The Committee Galway Cycling Committee

Regarding: GALWAY PUBLIC REALM STRATEGY

Development Description: The draft Galway Public Realm Strategy is a proposal for a vision of place, design guidance and outline project proposals to improve Galway's streets and public spaces.

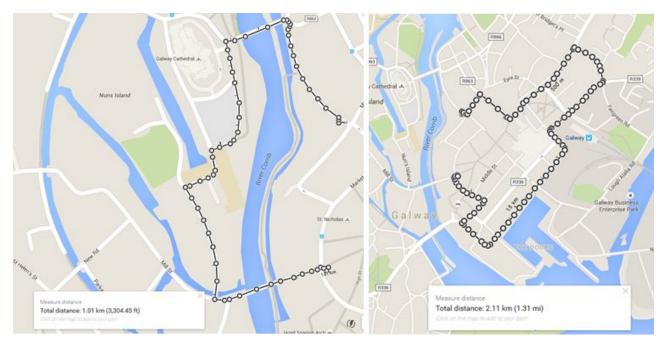
Figure 4.1 The nominal distance from Newtownsmith to Mainguard St is 340m. Because of the one-way restrictions in the city the actual distances required to reach Mainguard St are 1) 1km if travelling via Salmon Weir Bridge and Nuns Island 2) 2.11km if going via Eyre Square, Forster St and the hostile multilane one-way system around the docks.

Provision should be made for two-way cycling on all one-way streets. •

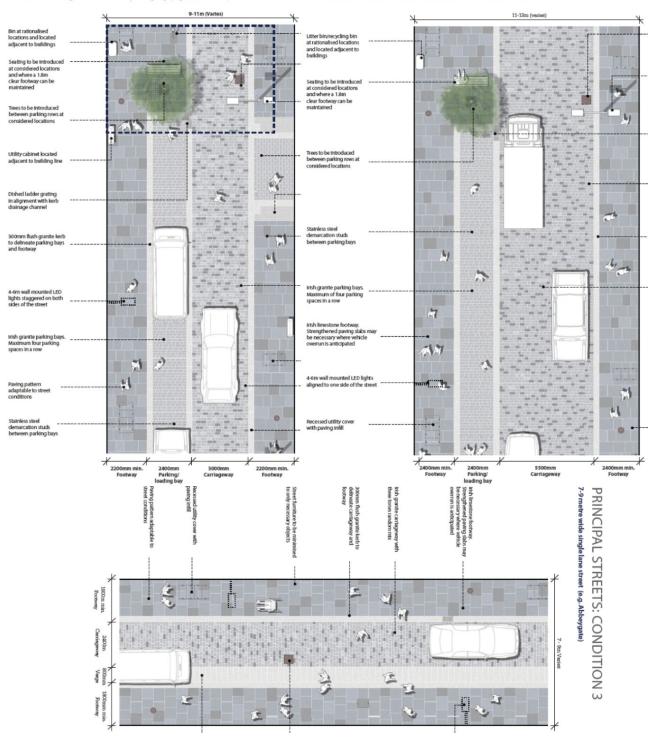
No space is indicated for cyclists in the design drawings for these streets, and it is telling that cyclists are not included in these drawings. It is as if cyclists have been airbrushed from the picture.

We note also the consistent trend in the design drawings for these streets: to continue to provide on-street parking, loading bays or narrow drop-off strips, even on the narrowest (7m) of these streets.

Figure 6.1 Image extract from DMURS illustrating the effects of corner radii on safe cycling.

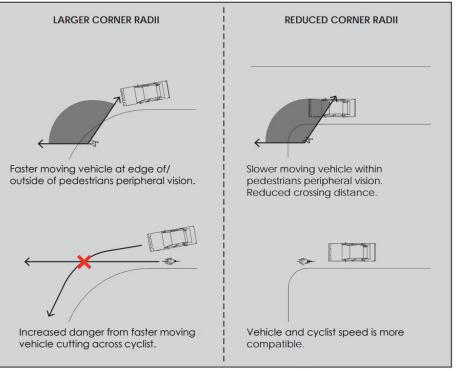
As per DMURS guidance, all corner radii on junctions with the "Pedestrianised Core" and "Principal Streets" of the Strategy should be no more than 3m (and preferably less than 2m). This systematic approach should be enabled by the removal and restriction of HGV movements within the extent of the area of the Strategy.

- All corner radii within the extent of area of the Strategy should be no more than 3m (and preferably less than 2m) as per DMURS guidance.
- A universal speed limit of 30km/hr should apply to all streets within the area of the strategy, • with lower speeds mandated on shared streets.
